21 October 2016

Project: Re-Roof Natchez Academic Center
Copiah-Lincoln Community College
Natchez Campus

Addendum No. 1

2
A-1 **Roof Plan - Existing Conditions & Demolition**
 $\frac{1}{16}'' = 1'-0''$
0' 10' 30' 50'

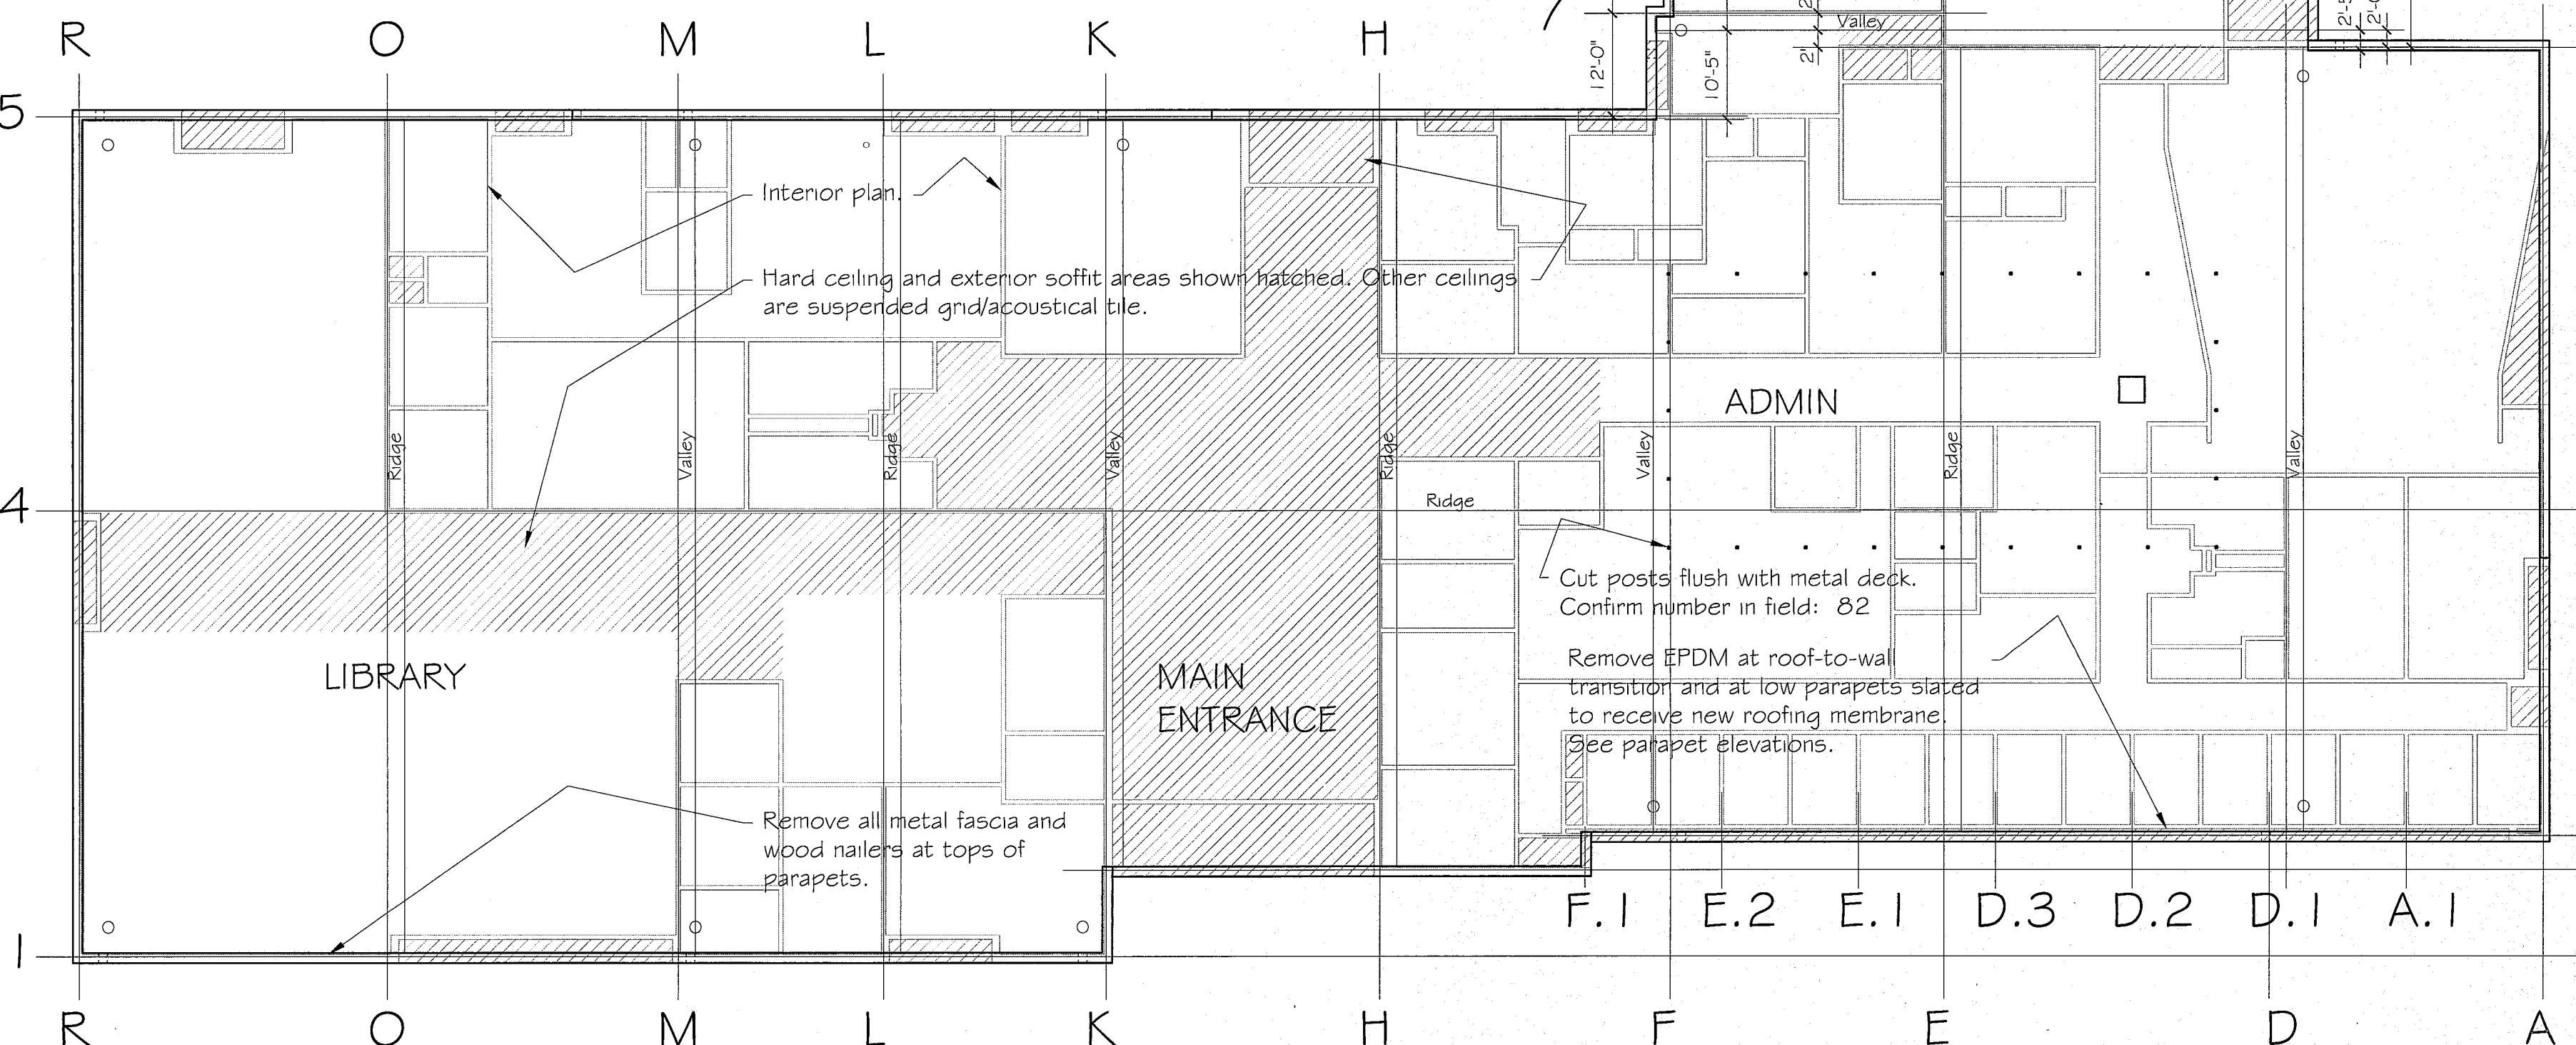
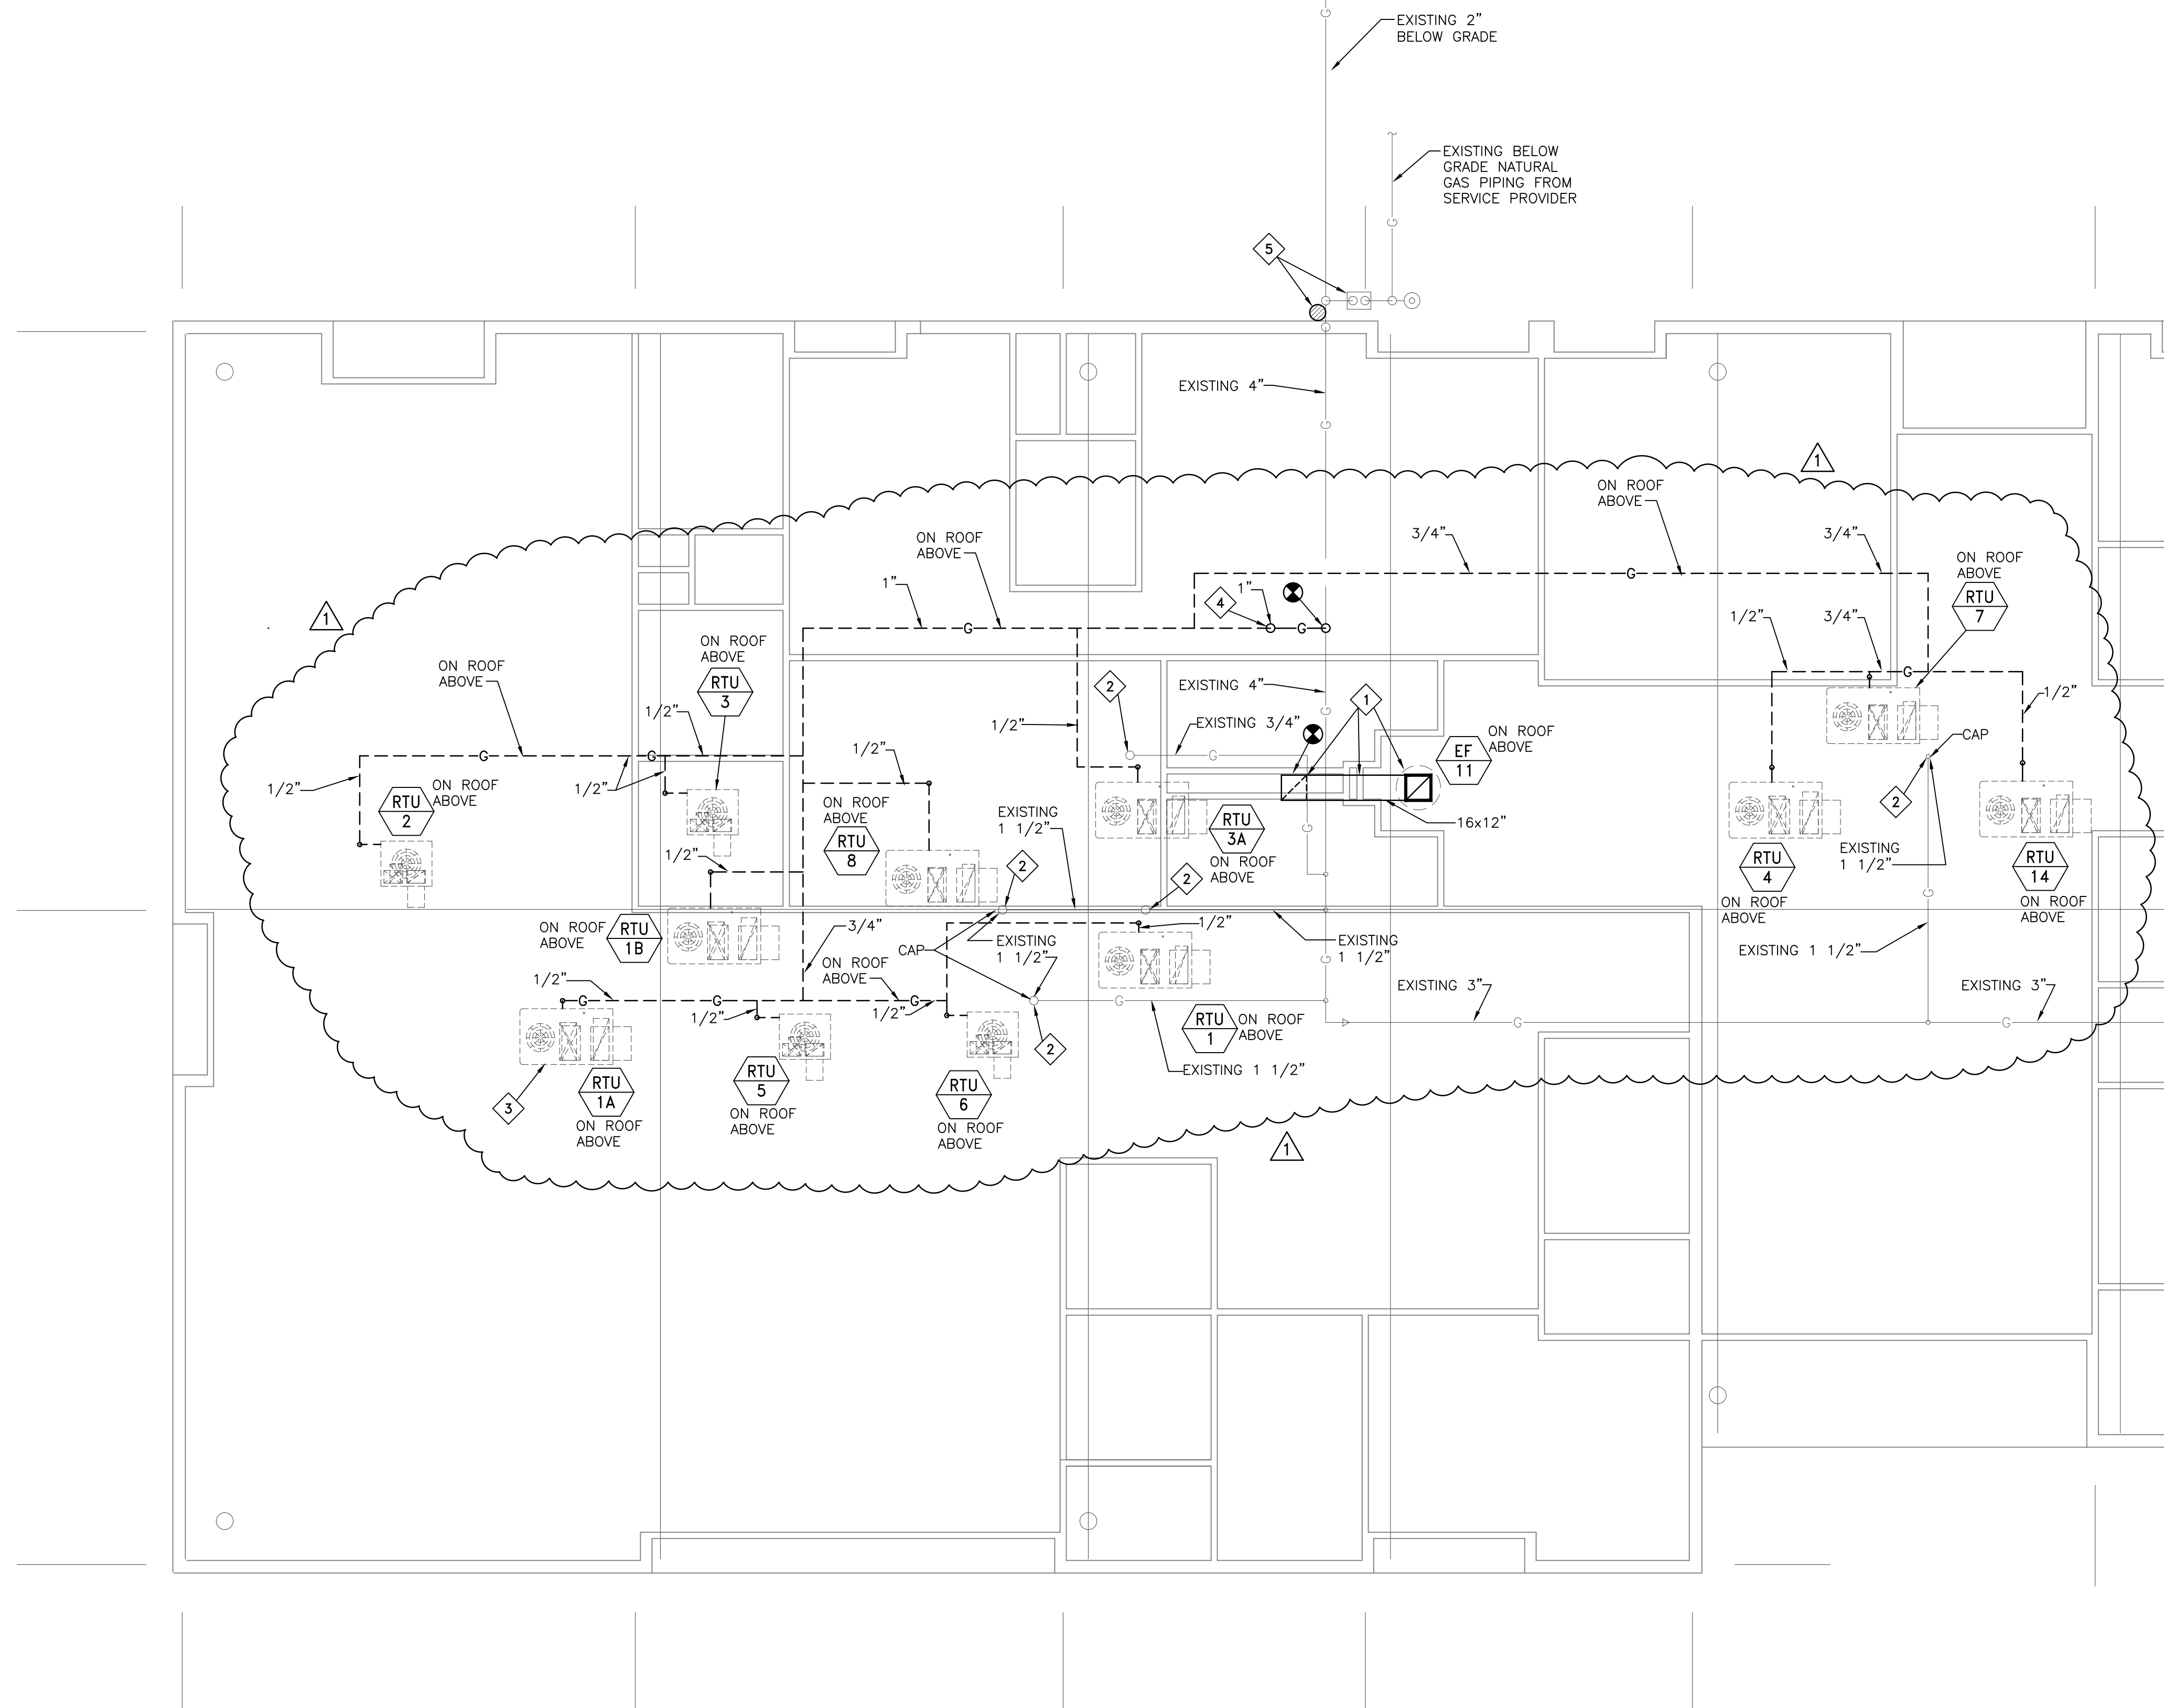
1) Sheet A-1

The attached sheet A-1 reprints the original document to show gray-scale lines lost in first printing. Specifically these lines show the Academic Center interior floor plan and areas of hard ceilings.

7) Demolition - Roofing

Amend note in Drawing 2/A-1 as follows:

Remove all gravel ballast to a location on campus as directed by Co-Lin. Remove and dispose of loose-laid top EPDM membrane and felt liner. Leave bottom EPDM membrane and 1" +/- insulation in place.

8) Demolition - Parapets

Amend notes in Drawing 2-A-1 as follows: Remove EPDM from all parapets.
